**Addendum No. 1 to the
Environmental Impact Report on the
American River Watershed Common Features Project/
Natomas Post-authorization Change Report/
Natomas Levee Improvement Program
Phase 4b Landside Improvements Project**

April 2018

State Clearinghouse No. 2009112025

Addendum No. 1 to the Environmental Impact Report for the Natomas Levee Improvement Program Phase 4b Landside Improvements Project

SHEET ID
BEN
C-102

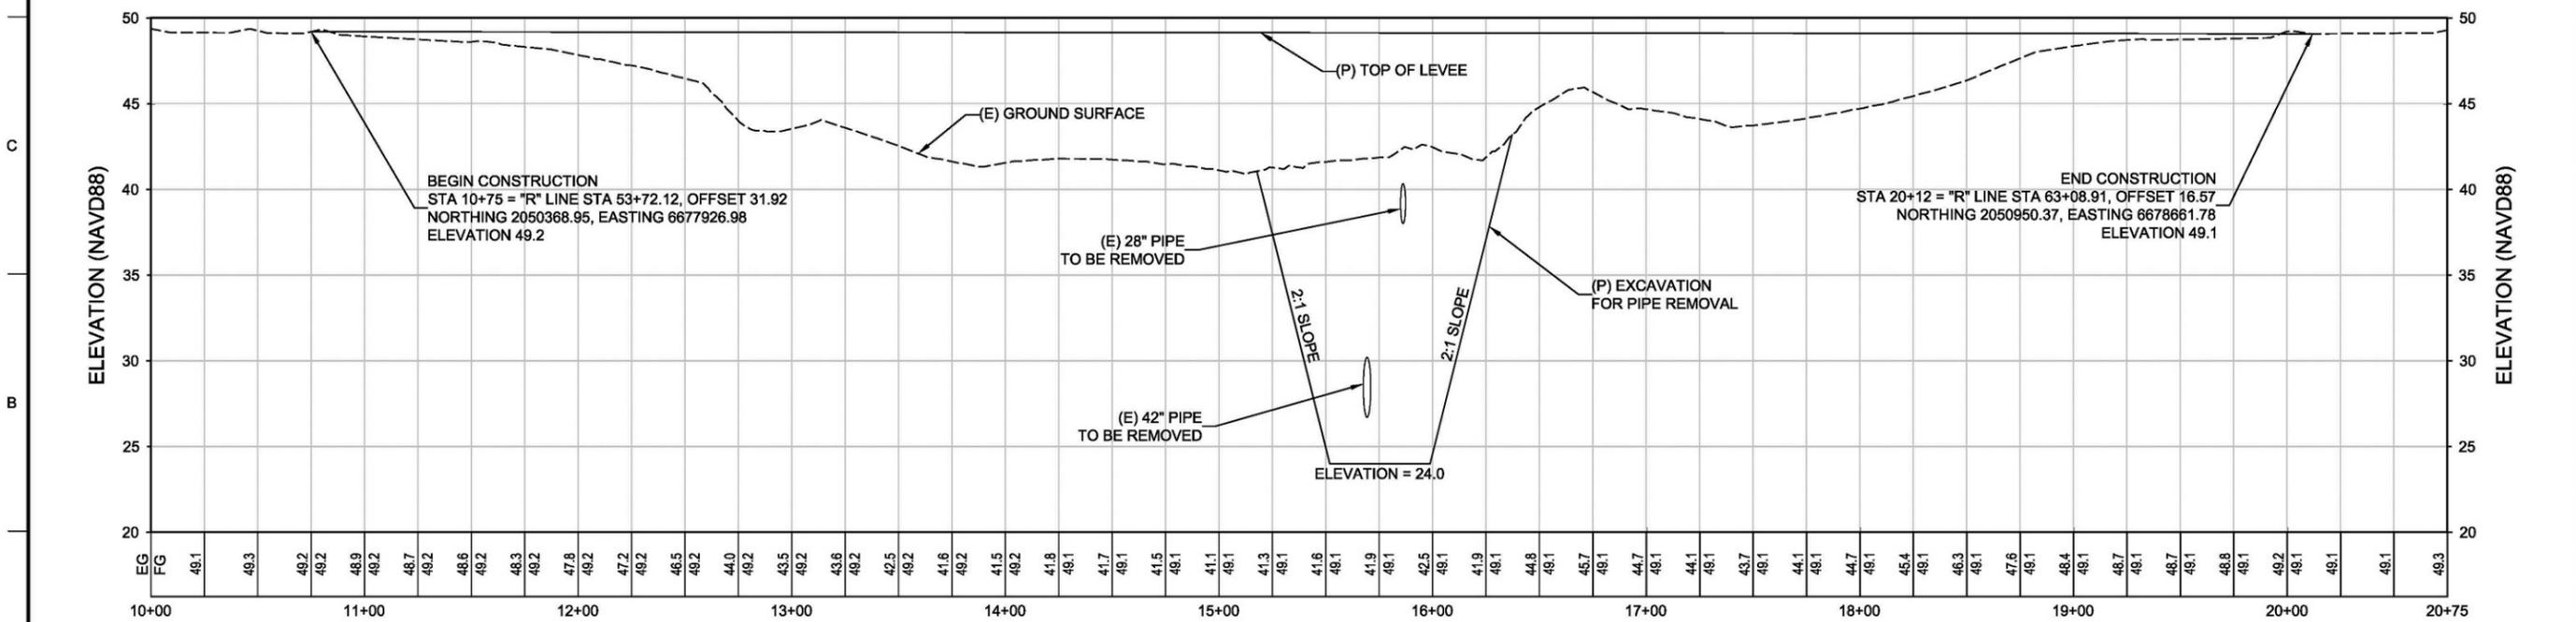
Abandoned pipes associated with the former Northern Main and Bennett Pumping Plants would be removed by temporarily degrading (excavating) the levee, removing the pipes, and reconstructing the levee with appropriate compacted fill. To reduce the amount of in-channel work, the valve box structures at the waterside toe of the levee would be left in place due to their function as retaining walls, but they would be cut shorter (i.e. reduced in height) so that they do not project above the ground surface. These valve box structures would be filled with a rock rip-rap material and the concrete sidewalls adjusted to grade. Additional rock would be placed in the NCC channel at the waterside toe to prevent further erosion on the steep banks. Waterside ramps would be removed and the waterside levee slope would be regraded to match the new waterside slope after the removal of the intake structures. The demolition and removal of remaining plant pipes and facilities at both Bennett and Northern Main Windows would be followed by the re-grading and raising of the levee crown alignment to match the adjacent levee sections, as described in the Phase 4a EIS/EIR.

This addendum evaluates filling the valve box structures with rip-rap and grade adjustments, removal of waterside ramps to match slope, and rock placed at the waterside toe. Other improvements would be as analyzed in previous environmental documents, including the Phase 4a EIS/EIR.

ATTACHMENT 'F'

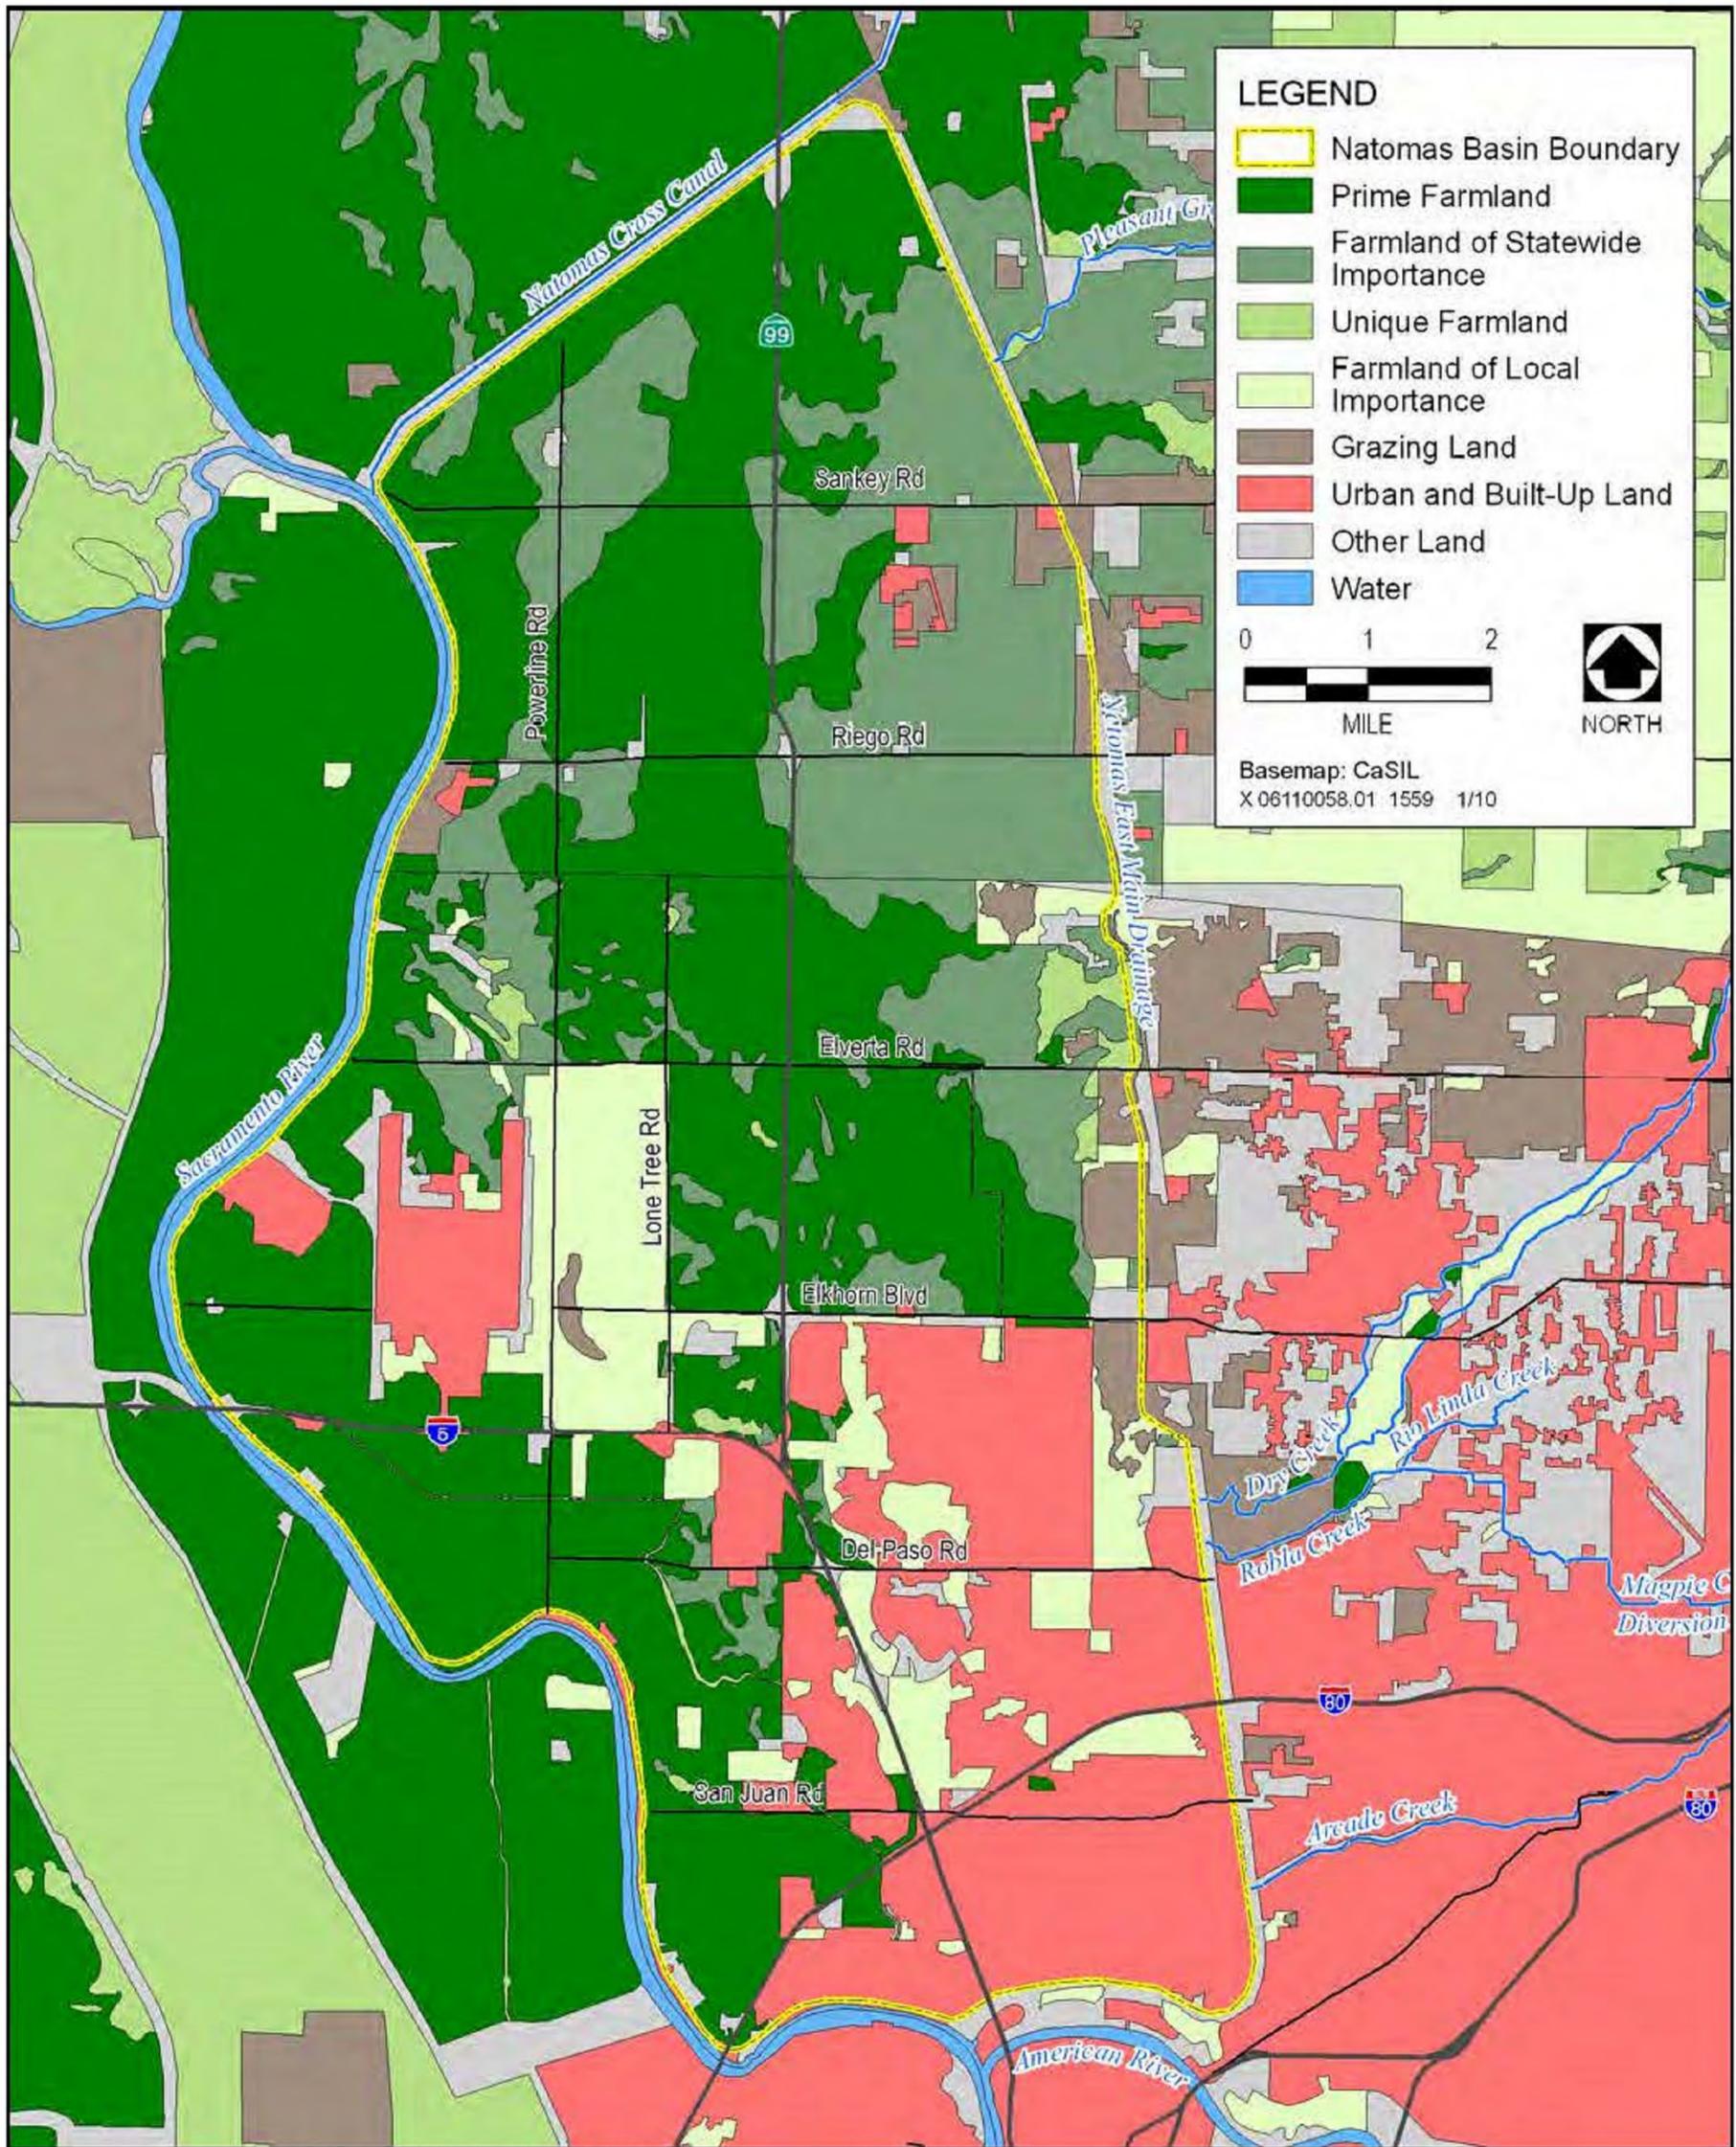
the toe of the levee (see discussion below). Structures to be removed include pipes through the levee, concrete sump and valve box structures, and three power poles formerly associated with the pumping plants. Two additional power poles would be relocated by Pacific Gas and Electric Company (PG&E) to facilitate construction. These poles would be removed and relocated prior to project construction at the former Bennett Pumping Plant. *The Final Environmental Impact Report on the Natomas Levee Improvement Program Phase 4a Landside Improvements Project* (Phase 4a EIS/EIR) (SAFCA 2009f) analyzed the removal of the structures within the levee section, installation of a cutoff wall, and levee raising at the former Northern Main and Bennett Pumping Plants. However, additional detail on these project components are now available and the cutoff wall installation is no longer included in the project.

The Vestal Drain is designed to take storm water runoff and irrigation tailwater drainage from the surrounding agricultural fields and transport this water to Pumping Plant No. 4, which then pumps the water into the NCC. The existing Vestal Drain is located adjacent the landside toe of the levee along the NCC, from approximately 1,500 feet east of Garden Highway to its connection with Pumping Plant No. 4, a length of approximately 1.5 miles. To reduce seepage along Reach D, the existing Vestal Drain would be relocated from its current position adjacent to the landside toe of the levee to a new alignment south of the Sankey Canal, approximately 250 feet southward from its current alignment. The new Vestal Drain would be between 8- to 20-feet-wide at the bottom and have 3H:1V side slopes. After construction of the new Vestal Drain, the existing Vestal Drain would be filled in using the material excavated from the new drain. This excavated material would be stockpiled temporarily near the existing drain until the new drain is completed. The new Vestal Drain would cross under the existing Bennett Irrigation Canal and connect into the existing North Drain channel using box culverts. The Phase 4b EIS/EIR analyzed moving the Vestal Drain 400 feet southward from its current alignment; the project modification identified in this addendum (moving the drain approximately 250 feet southward) would have reduced effects compared to the project analyzed in the Phase 4b EIS/EIR. This addendum considers the use of box culverts for undercrossing of the Bennett Irrigation Canal and the connection to the North Drain channel.
